Review of “Harmonization of global surface ocean pCO₂ mapped products and their flux calculations; an improved estimate of the ocean carbon sink” by Tim DeVries

We would like to thank Tim DeVries for the thoughtful comments and suggestions. In the following we will respond (in italics) to each comment.

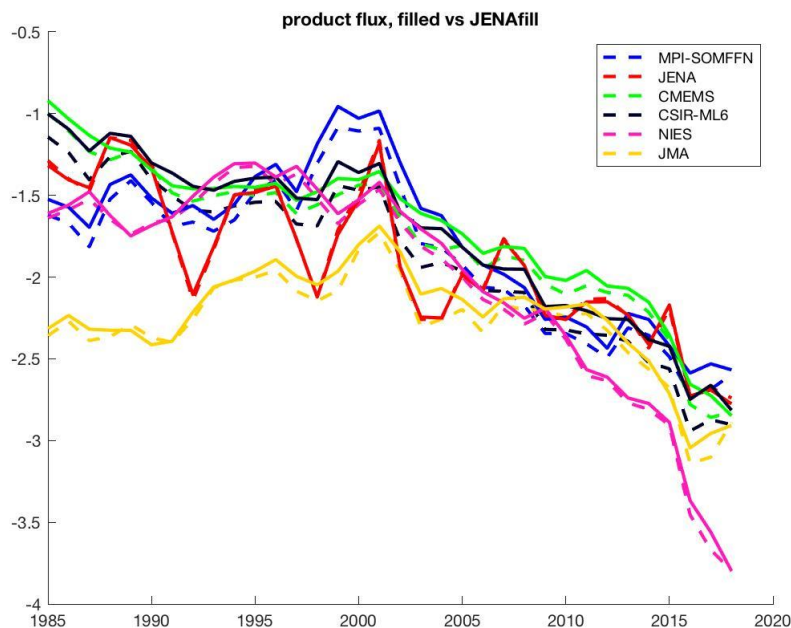
R2: In addition to this concern about how the results are presented, I have a general concern with how the missing areas are filled in each product. Filling in the missing

areas with the estimates of one single product (the MPI-ULB-SOMFFN) is problematic, as this implicitly assumes zero uncertainty in the gap-filled areas. Rather, these areas are precisely where the uncertainty is the largest, and indeed the method used here depends on several assumptions which have their own uncertainties (which of course is not reported in the uncertainty because it does not contribute to the ensemble spread). The best way to fill in these missing regions is to extend the individual methods to global coverage, as this would provide a better estimate of uncertainty in these regions. In general, I am concerned that using the MPI-UMB-SOMFFN product to fill in these gaps will become entrenched, and reduce the motivation for extending the various methods to global coverage. The authors should explicitly warn against this, and discuss the necessity of having multiple independent estimates of the air-sea CO₂ flux in these regions (high latitudes, shelves/seas) in order to arrive at a good estimate of the uncertainty and an improved estimate of the global air-sea CO₂ flux. In the meantime, the authors might want to consider using at least one other estimate of the air-sea CO₂ flux in these missing regions — the Jena-MLS has global coverage and so could be used there as well.

We thank the reviewer for their suggestion of using the Jena-MLS product as an independent estimate of the missing regions. While this does seem like a plausible option from the full-coverage map shown, the Jena-MLS product is stated to be an “open-ocean” product. The creator of the Jena-MLS product (Christian Rodenbeck) specifically cautioned us against using the product as a coastal estimate, specifically stating that the Jena-MLS product is an open-ocean product.

For completeness, we calculated the resulting flux with the Jena-MLS product pCO₂ used to fill in missing gridcells in the remaining products and present the resulting global mean CO₂ flux time series here (dashed lines) along with the flux with filling by the SeaFlux package area-filling method employing MPI-UMB-SOMFFN (solid lines).

*Figure 2 has an inlay of time series of the scaling factor * mean pCO₂ from the climatology. We have also included a time series of the scaling factor itself here for your reference.*

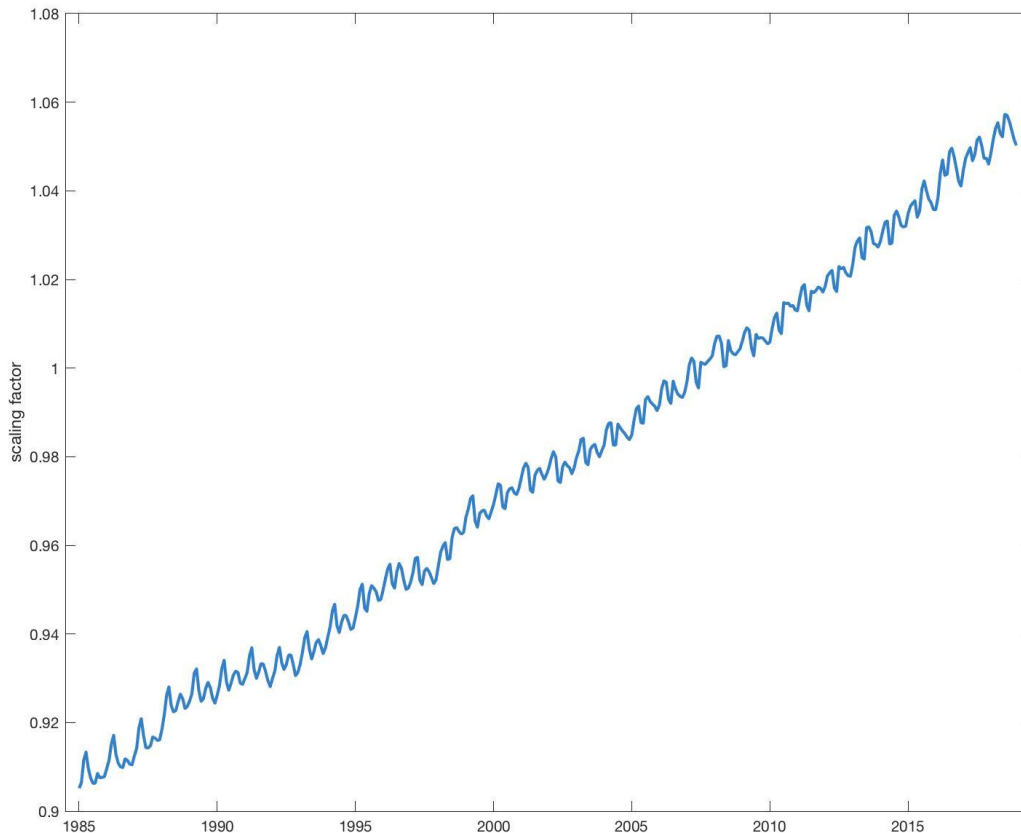
R2: Equation (2): The authors should plot this scaling factor out over time for the different models.

Response: Thank you for this comment. There is in fact only one scaling factor which is applied to the climatology. Then this scaled climatology is used to fill in the missing areas of each product. So if multiple products are missing pCO₂ values for the area 80-90N; 0-10E, for all of 2016 for example, all of those models will be filled with the same values for that area and time period. The filling does not differ by product. We have elaborated on this further in Section 2.1 to ensure this method is clear.
